# New England Highway upgrade between Belford and the Golden Highway

Submissions Report

Roads and Maritime Services | July 2018

Prepared by Arup and Roads and Maritime Services  
RMS.18.900  
ISBN. 978-1-925797-52-7

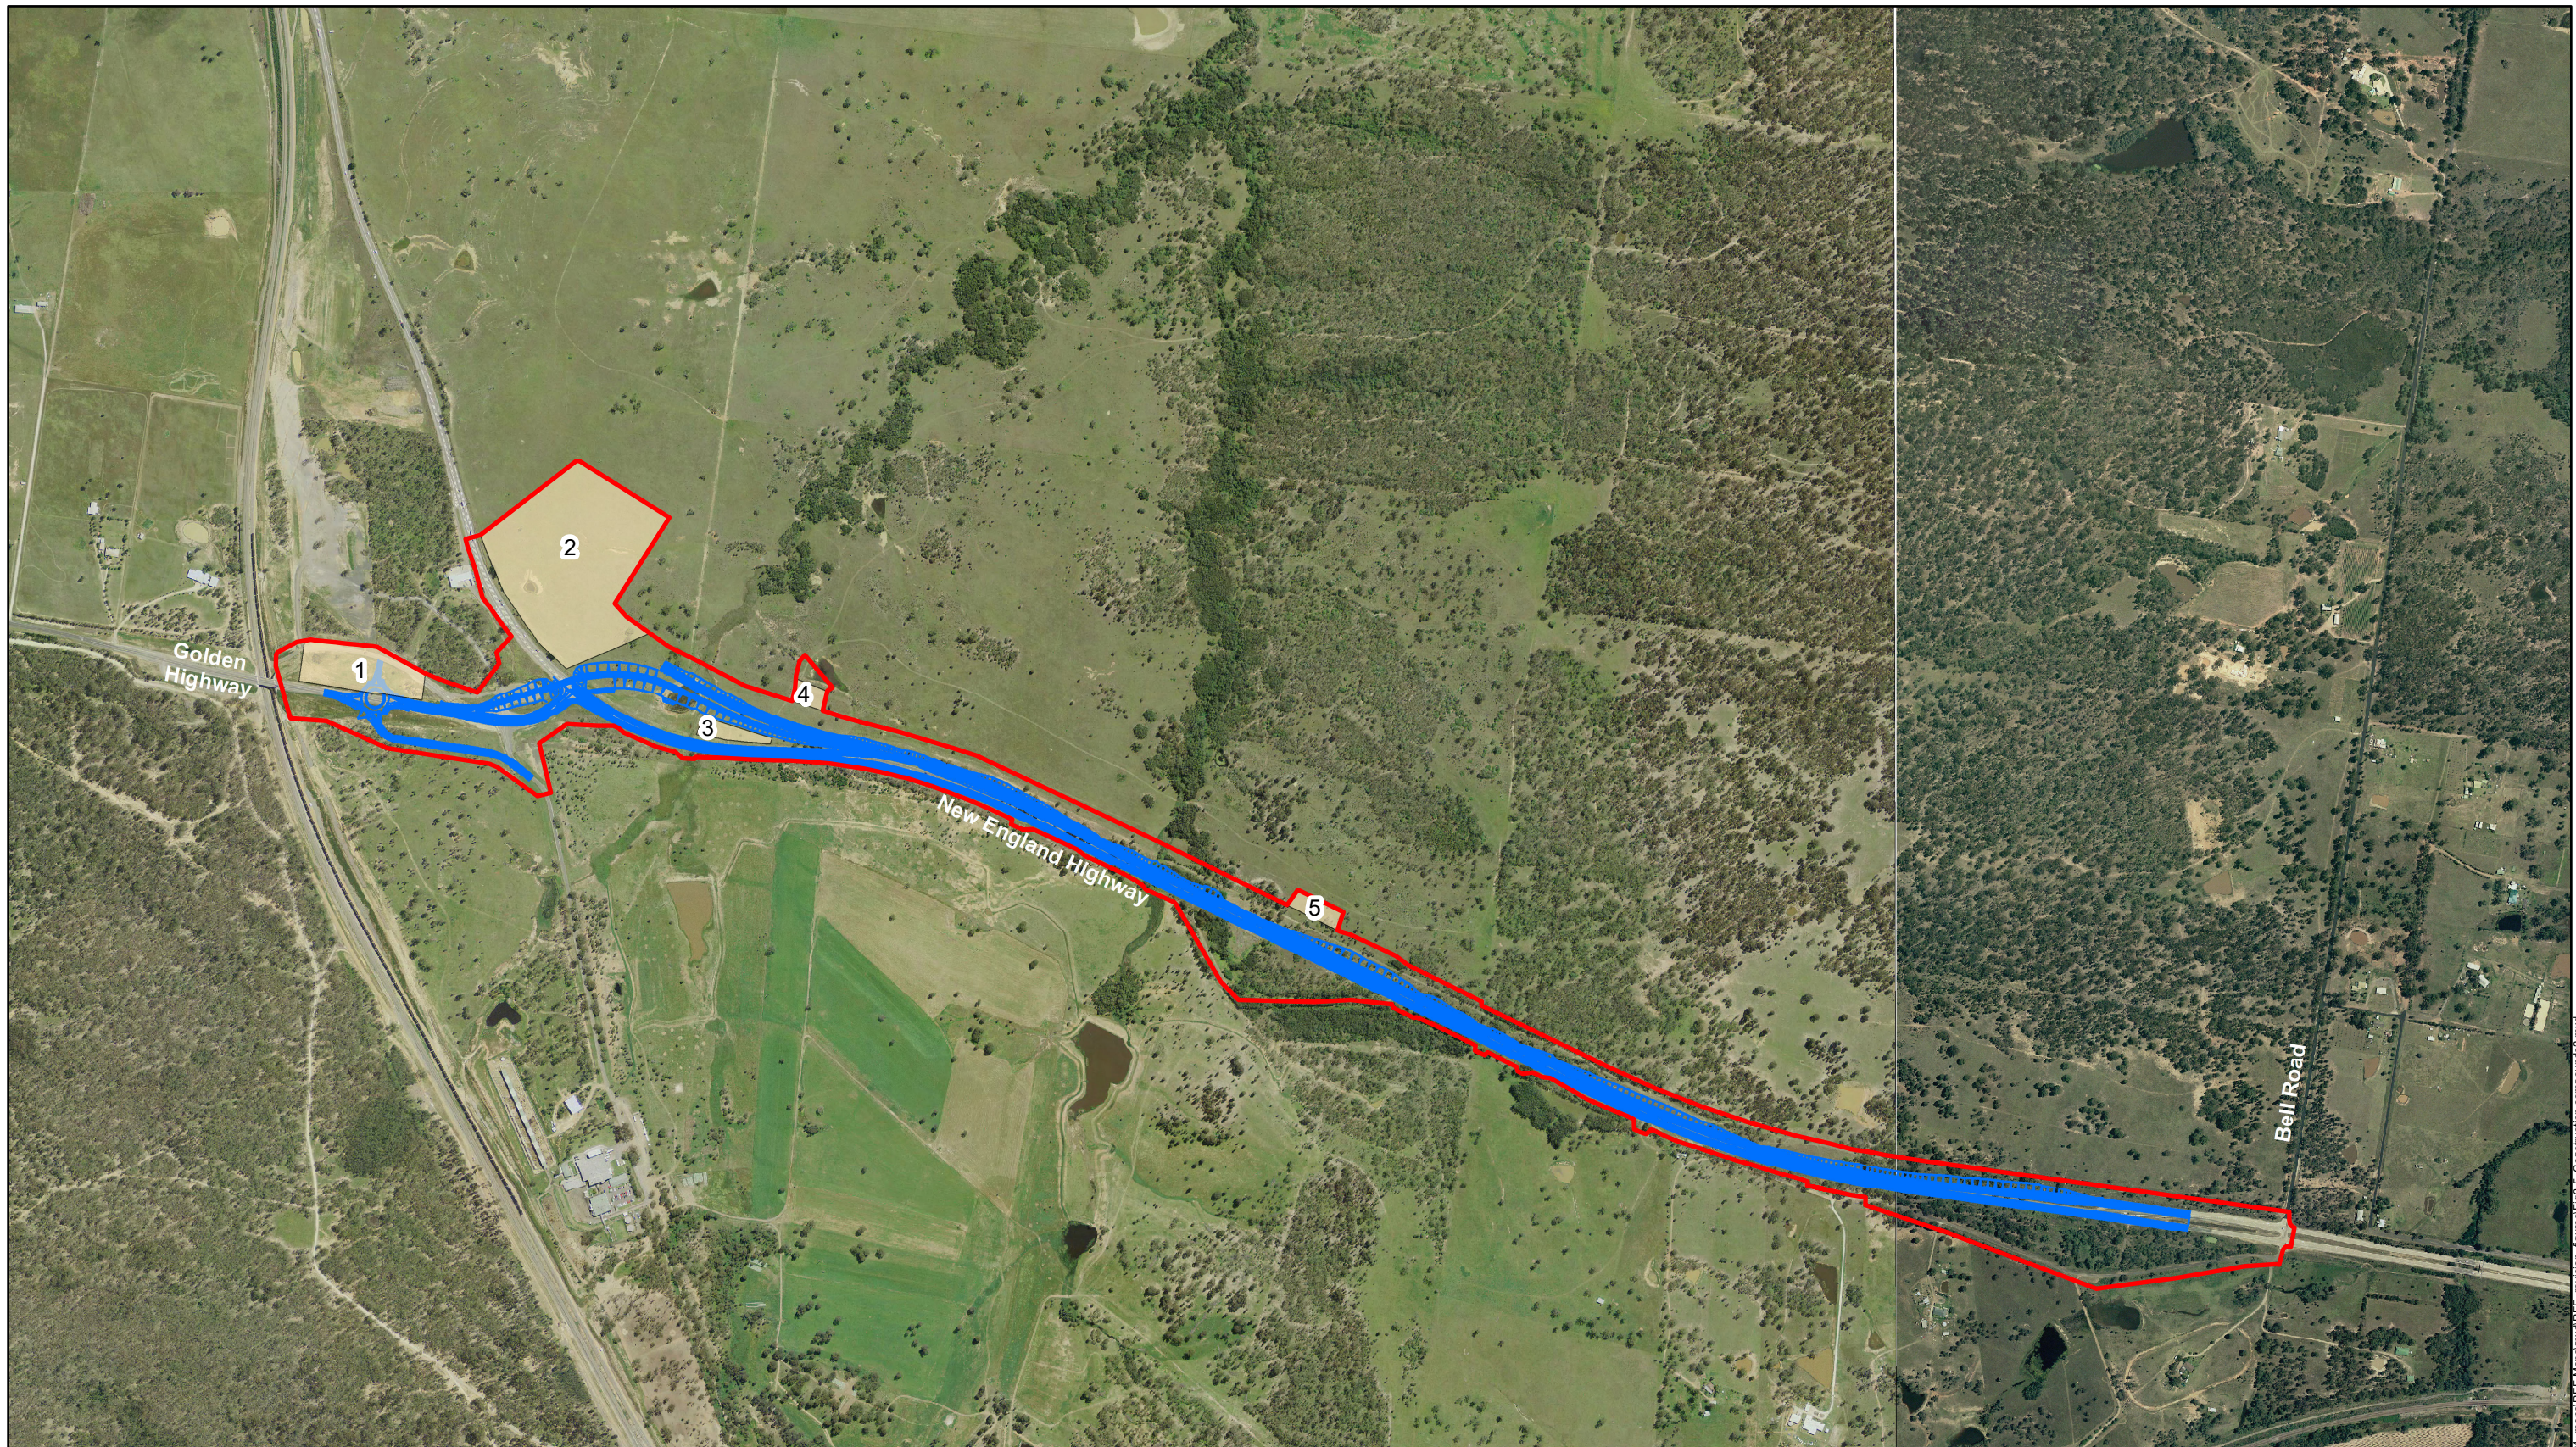
Due to realignment of the flyover and the opportunity to reduce property acquisition, the potential construction compound locations outlined in the REF has been revised. Figure 3-5 shows the location of the proposed construction compounds and sites.

The main compound site between the proposed flyover and the New England Highway (noted as possible main construction compound 1 on Figure 3-8 of the REF), has been removed from the project due to realignment of the flyover. The loss of this area has been replaced by modifying the compound site to the north of the proposed flyover (noted as possible main construction compound 2 on Figure 3-8 of the REF). This site is identified as Area 2 on Figure 3-5 and has been realigned since the REF to increase the area of the compound site, while minimising impacts to sensitive areas.

The auxiliary construction compound identified adjacent to the Golden Highway, identified as Area 1 on Figure 3-5, remains as set out in the REF. This compound would provide for additional material handling, stockpiling and facilities.

Additional areas (Areas 3, 4 and 5 on Figure 3-5) have also been identified for potential use as construction site and include areas south of the new eastbound entry ramp, south of the dam, and north of the New England Highway towards the middle of the project. All construction sites have been located to avoid impact to Aboriginal heritage sites and native vegetation where practicable.
